Approved
ORNL WORK PLAN
 Operations, Maintenance and Services
 Work Plan Name / Rev: MWP057337 / 1
 Expiration Date: 3/21/2026

WORK SCOPE/DESCRIPTION				
Requester (Name/Badge/Division):	Palcu, Lucian / 03035184 / X108			
Location of work (Bldg/Rm/Other):	3525 / / No CCP include in this package.			
Work Plan Title:	Replace Motor Controls for K-9 and K-7 Office Area Supply and Charging Area Supply.			
Description of Service/Work Needed: This work plan covers the work associated with the rebuild and upgrades of motor control components and wiring for the K-9 and K-7 office area supply and charging area supply. The existing electrical and mechanical components have been operated beyond their designed life and are beginning to malfunction; they will be replaced with modern, approved electrical and mechanical components. K-9 bucket, which feeds the office area supply fan, is located in compartment 1-A of Motor Control Center (MCC) #2, whereas K-7 bucket that feeds the charging area supply fan is located in compartment 2-B of Motor Control Center (MCC) #1.

SECTION 1: CHANGE ORIGINATION / IDENTIFICATION			
Work Package No. MWP057337	Facility 3525	Date 1-5-2022	Originator Name / uid L. A

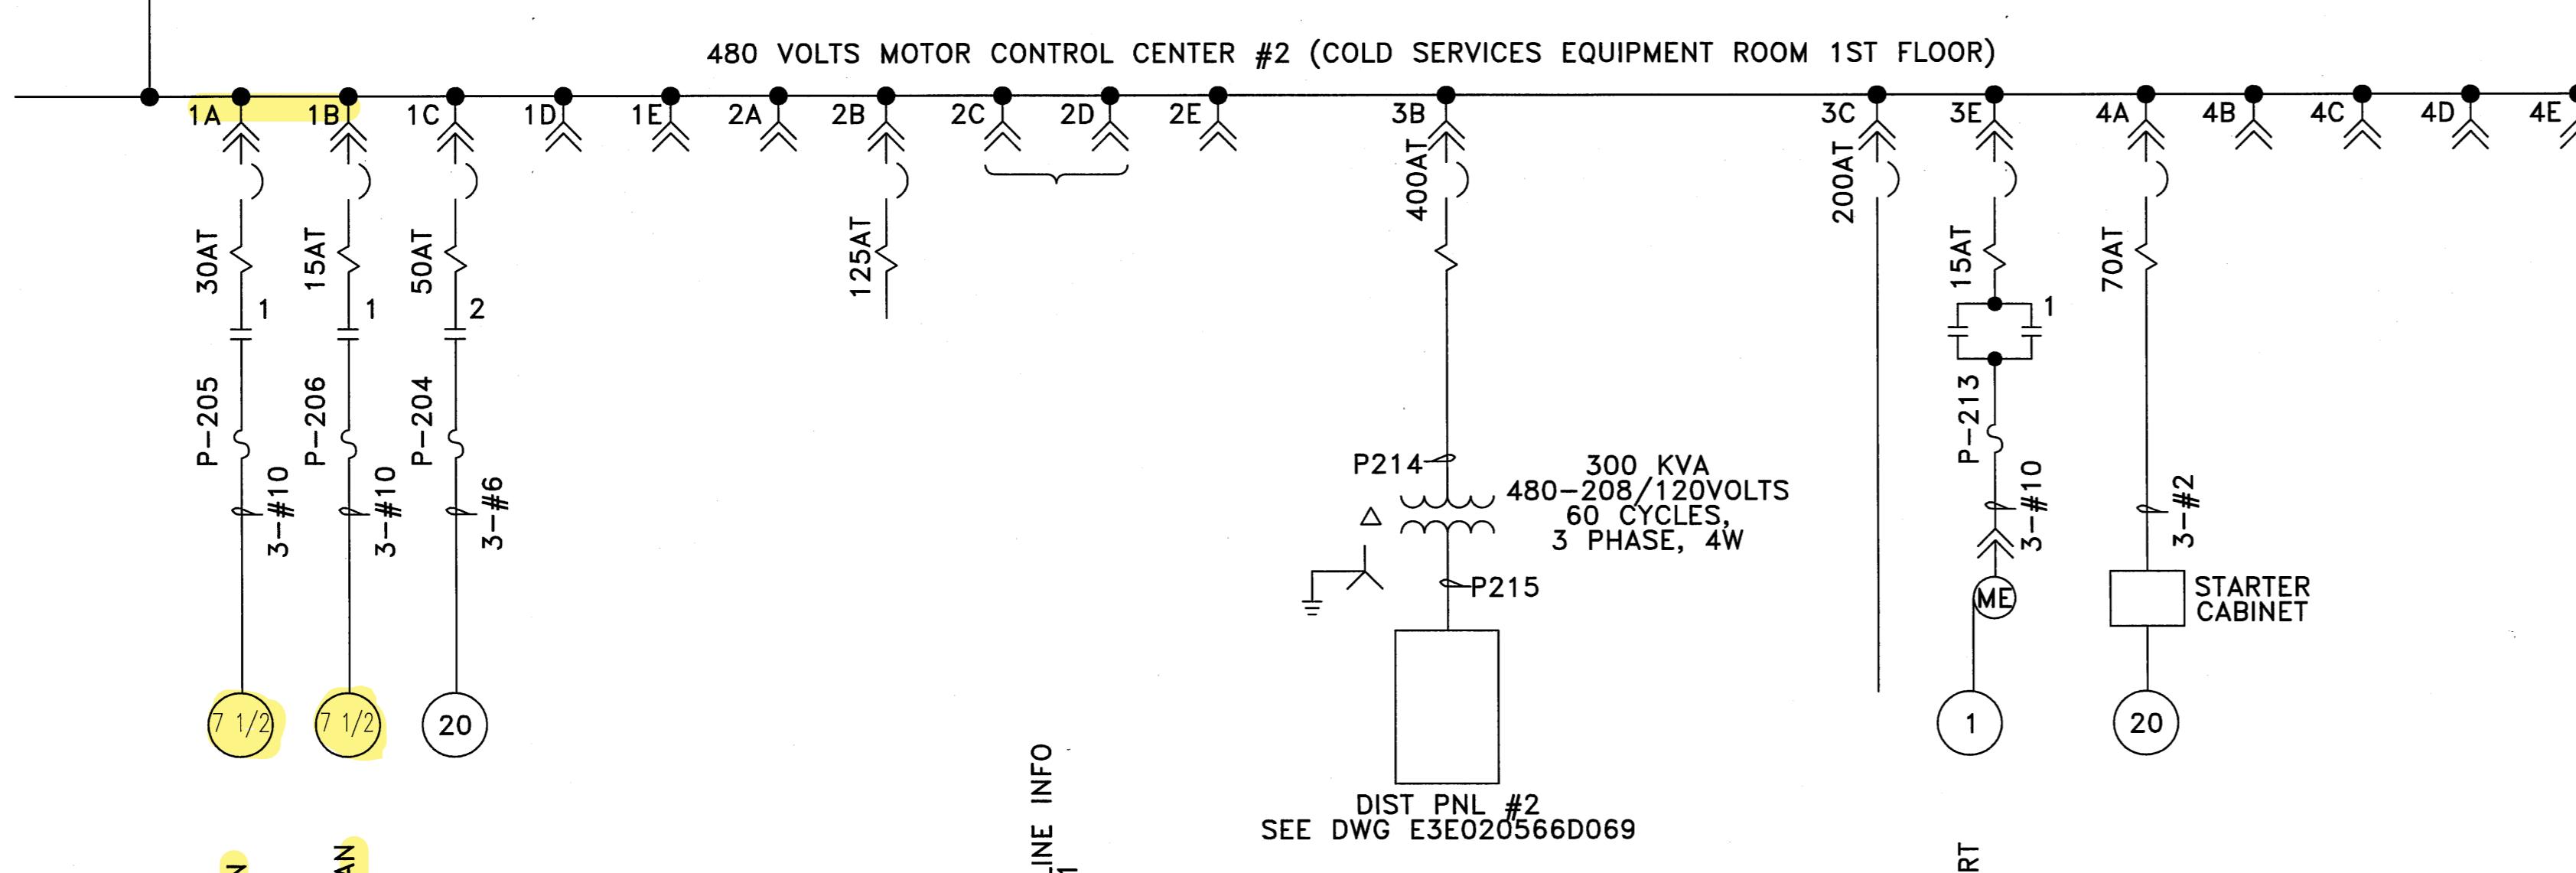
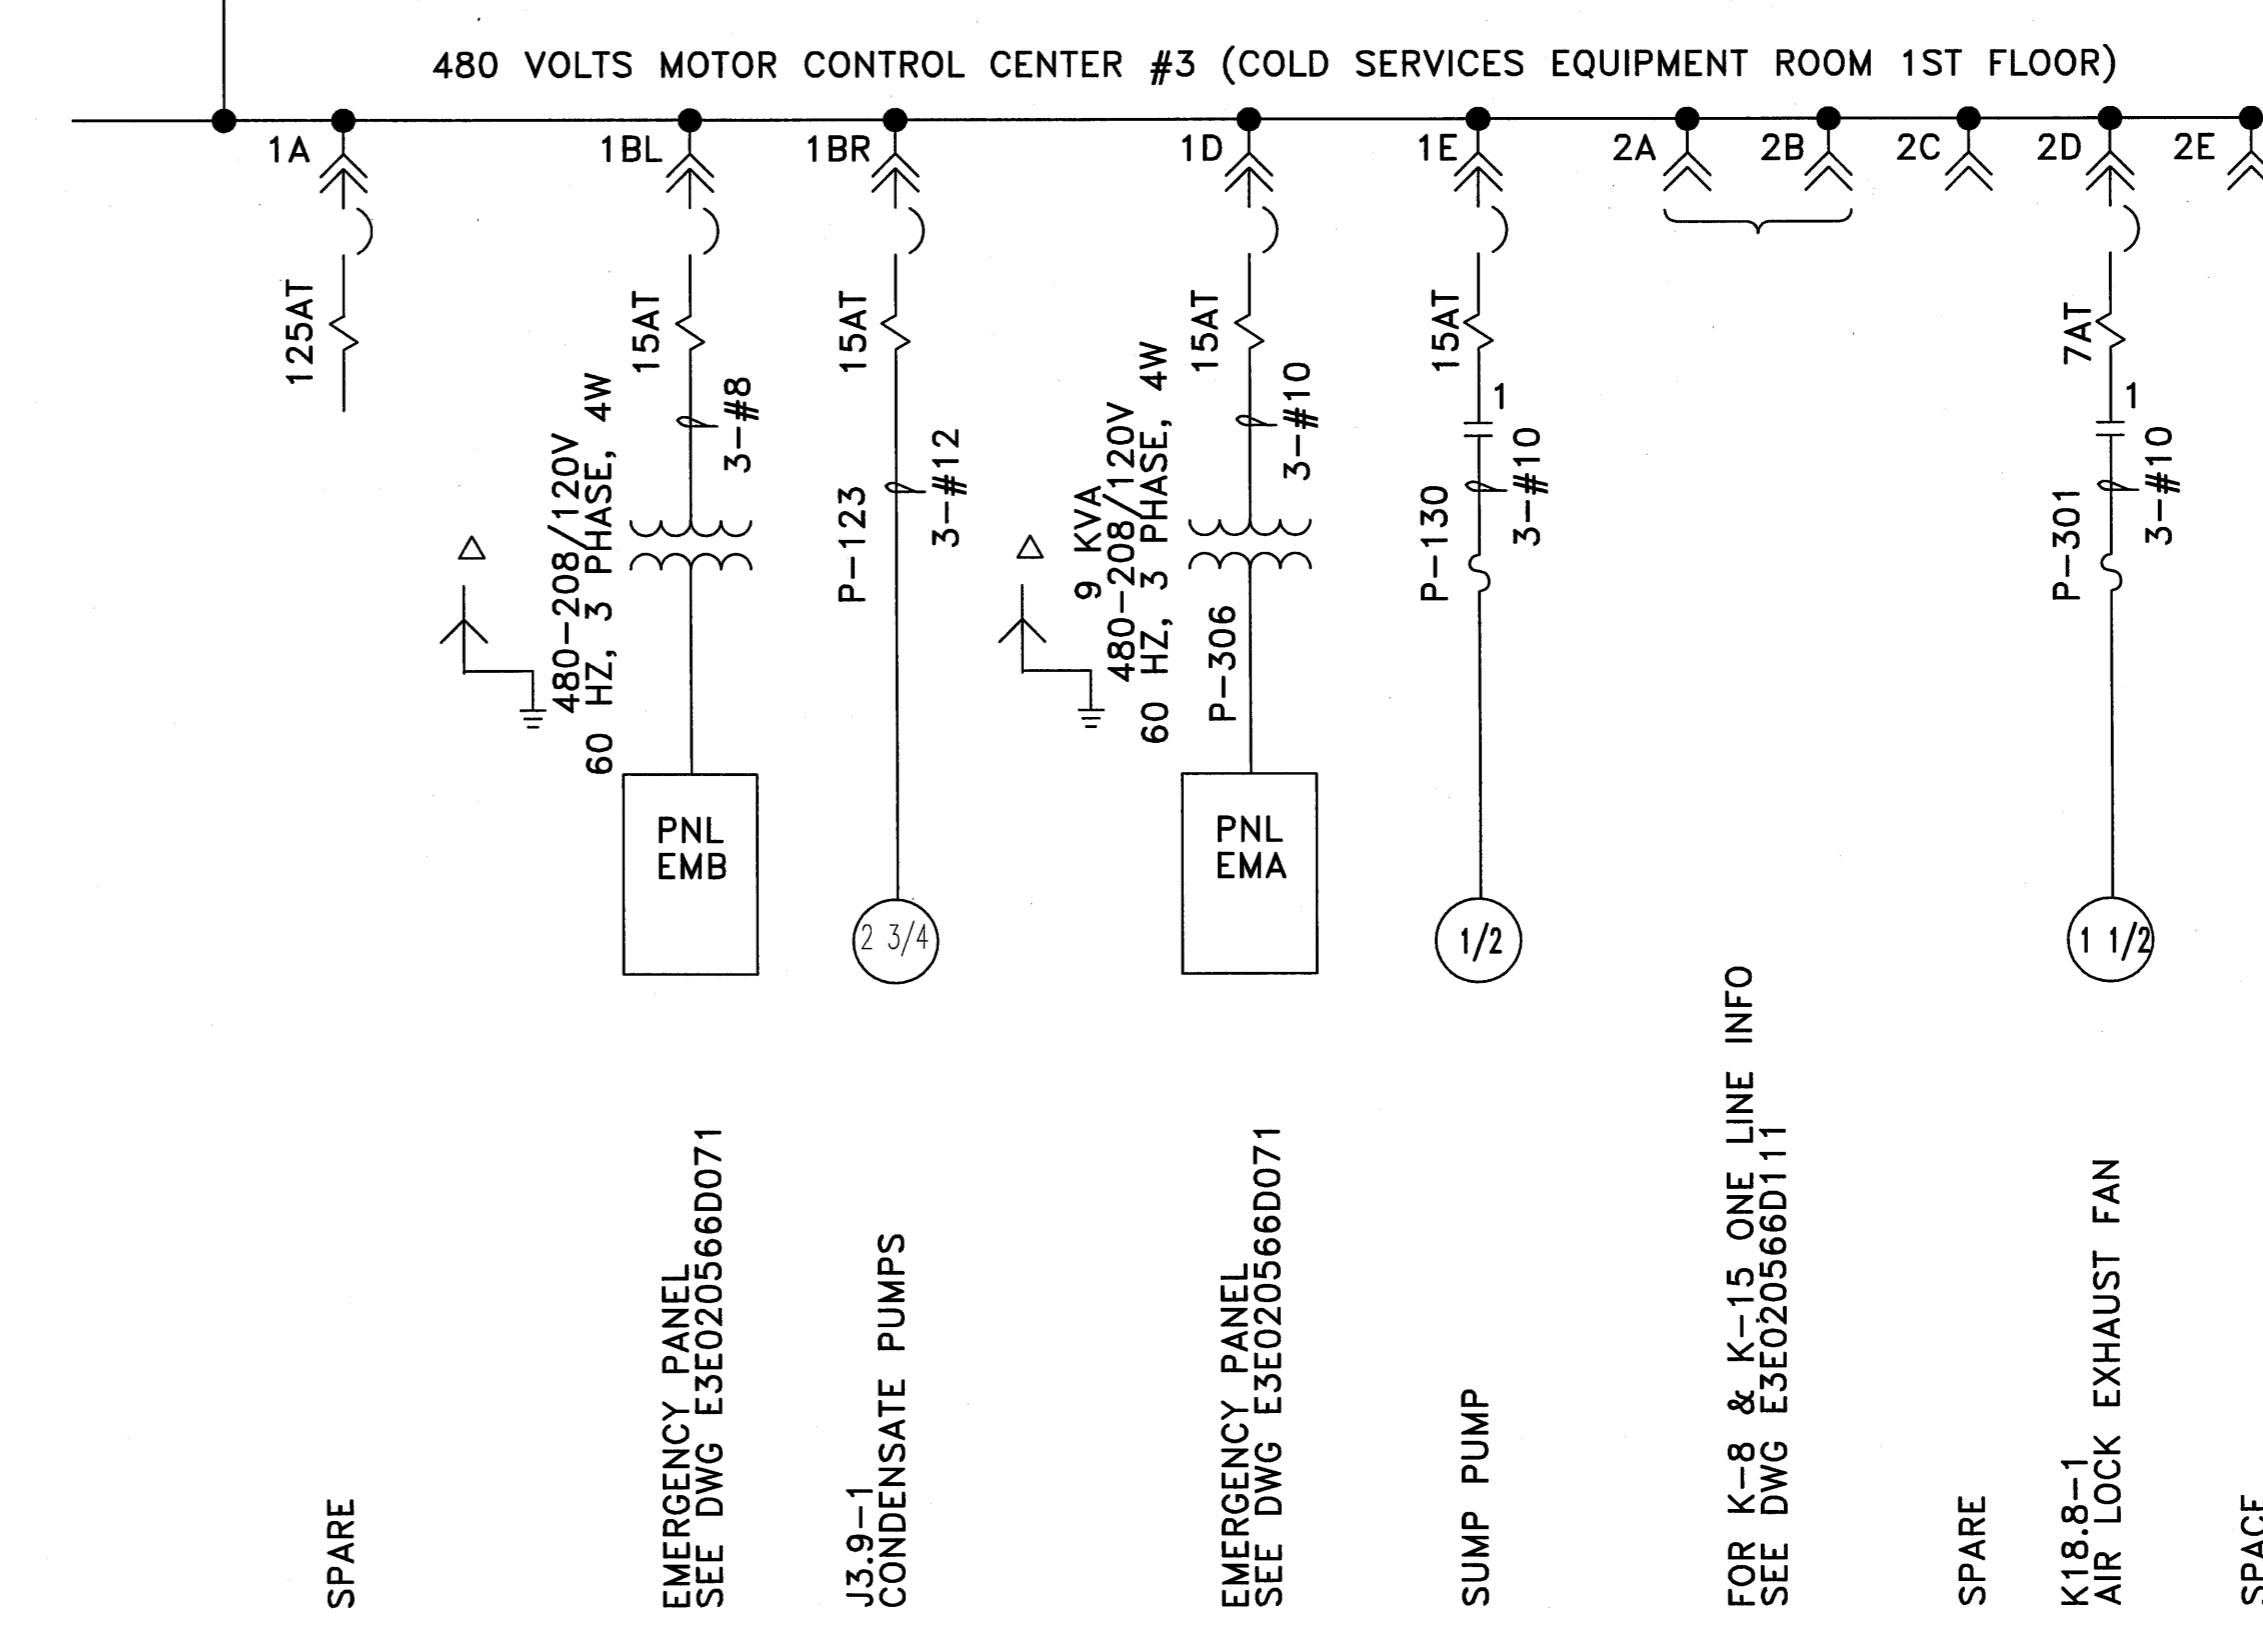
<p>Drawing change notice (DCN) NNFD-3525-DCN-157 provides the document changes to be made to the 3525 Facility drawings to document the changes made by this BOPM and associated workplan. Drawings E3E020566D067 and E20566Y514E will be revised to reflect these changes.</p>		
<p>New power and control wiring may be installed if required in new and existing conduit between the MCC, the Heating Ventilation and Air Conditioning control panel and the supply fan motor if required.</p>		
<p>All work shall be performed in accordance with NFPA-70 and NFPA-70E. All electrical components may be substituted with an engineering-approved equal part. The installation work will be completed under Work Package No. MWP057337, <i>Replace Motor Controls for K-9 and K-10 Office Area Supply and Exhaust Fans</i>. The work covered by this work plan includes the following major evolutions:</p> <ul style="list-style-type: none"> • perform Complex L/T/V as detailed in the work directions section • removal of MCC buckets to rebuilt with listed components as detailed in the BOPM, and by following the electrical schematic(s) attached to it • install new MCC bucket control components • as needed, install new power and control wiring in new and existing conduit between MCC, the HVAC control panel, and the supply fan motors • complete all field installation • perform functional testing on the pump motors before returning to service, and • perform 3525 Facility ventilation fan interlocks testing
